Millennium Bulk Terminals  
NEPA EIS c/o ICF International  
710 Second Ave Ste 550  
Seattle WA 98104

Millennium Coal Terminal-Longview-Review of DEIS

Millennium Bulk Terminal-Longview-Review of DEIS  
November, 2016 Public Comment  
Chris Turner 8 Cedar Gates RD Longview WA 98632

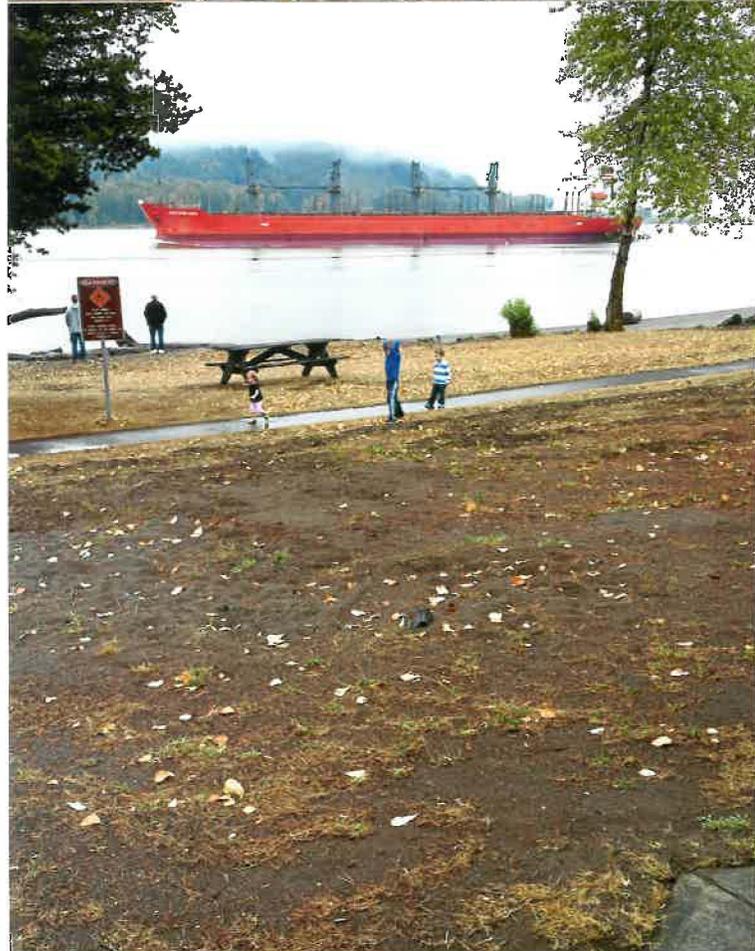
I mentioned the load-bearing capacity of the project site at Millennium before. The coal stockpile area CANNOT SUPPORT the weight of the coal. I would like to address it further:

Specifically, a detailed "EARTHQUAKE GEOTECHNICAL ASSESSMENT" should be required before the issuance of the Final EIS.

1. HIGH POTENTIAL OF LIQUEFACTION
2. TWO AQUIFERS
3. PRELOADING OF STOCKPILE AREA

A professional earthquake engineer needs to determine the best method to address the soil stabilization considering the final extreme weight of the preloading and the coal. At the same time, considering the aquifers, and the liquefaction issues relating to lateral spread etc.

My main concern is the insufficiency of the soil stabilization mitigation proposal and lack of adequate professional oversight in the process. Particularly, the final stabilization effort and it's ability to protect the underlying aquifers from contamination, and possible damage or even collapse under the excessive weight of the coal etc.

This Earthquake Geotechnical Assessment should be done BEFORE the FINAL EIS because of it's profound effects on the entire project. Besides, it's possible that currently available soil stabilization mitigations will not overcome the project site's deficiencies or protect our aquifers.
